Access Compliance Report

Public Rights-of-Way

(Curb Ramps)

Intersection ID: 10017651	Main Street: GRIER_SPRINGS_LN	Cross Street: N/A	Location: S
ADA ID: 6AF74C113AB3	Ramp Type: PerpDiag	Initial Pass/Fail: Fail	Overall Compliance: No
Severity Score: 48.75			
Codes/Mitigation Info/Possible Solution		Field Measurements/Component Compliance

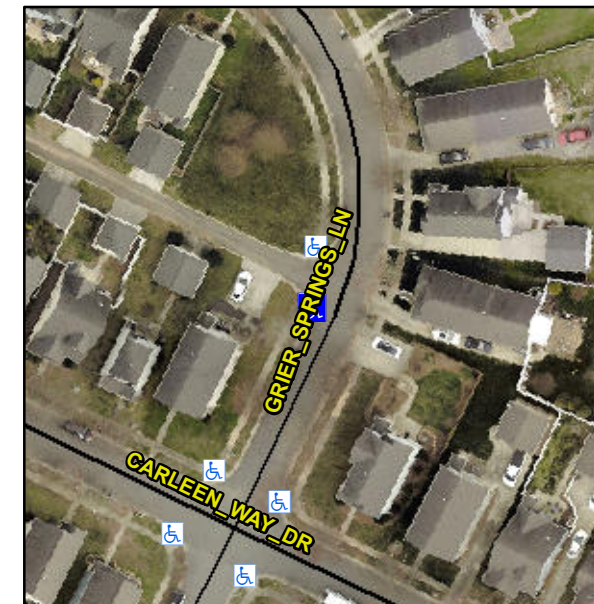
R304.5.1, R304.2.2

Compliance	Description	Data	Compliance	Description	Data
N/A	Ramp Length (in)	45.0	No	Ramp Slope (%)	8.4
No	Ramp Width (in)	28.5	Yes	Ramp XSlope (%)	3.7
N/A	Flare Type LT	N/A	N/A	Flare Type RT	N/A
N/A	Flare Slope LT (%)	N/A	N/A	Flare Slope RT (%)	N/A
N/A	Flare Traversable LT?	N/A	N/A	Flare Traversable RT?	N/A
N/A	Landing Length (in)	N/A	N/A	DWS Provided?	N/A
N/A	Landing Width (in)	N/A	N/A	DWS Contrast?	N/A
N/A	Landing Slope (%)	N/A	N/A	DWS Length (in)	N/A
N/A	Landing X Slope (%)	N/A	N/A	DWS Full Width?	N/A
N/A	Landing Curb? (Y/N)	N/A	N/A	DWS Offset (in)	N/A
N/A	Shared Landing?	N/A			
N/A	Gutter Ponding?	N/A	N/A	Gutter Slope (%)	N/A
N/A	Gutter Lip Ht (in)	N/A	N/A	Gutter X Slope (%)	N/A
N/A	Painted X Walk1?	No	N/A	Painted X Walk2?	No
	X Walk 1 Direction	To E		X Walk 2 Direction	To N
N/A	X Walk 1 Width (in)	N/A	N/A	X Walk 2 Width (in)	N/A
	X Walk 1 Slope (%)	7.0		X Walk 2 Slope (%)	1.8
	X Walk 1 X Slope (%)	2.0		X Walk 2 X Slope (%)	7.0

N/A	Ramp inside XWalk1?	N/A	N/A	Ramp inside XWalk2?	N/A
	Road Slope (%)	4.8	N/A	Clear Space?	N/A
	Road X Slope (%)	5.6	N/A	Clear Space to XWalk (in)	N/A
N/A	Any Obstructions?	N/A	N/A	Storm Grate/Utility Hazard?	N/A
	Obstruction Type			Storm Grate/Utility Type	
		N/A			N/A
		Yes		Surface Condition? (G/P)	Good

Remove & Replace Curb Ramp With Two New Directional Ramps or Equivalent.
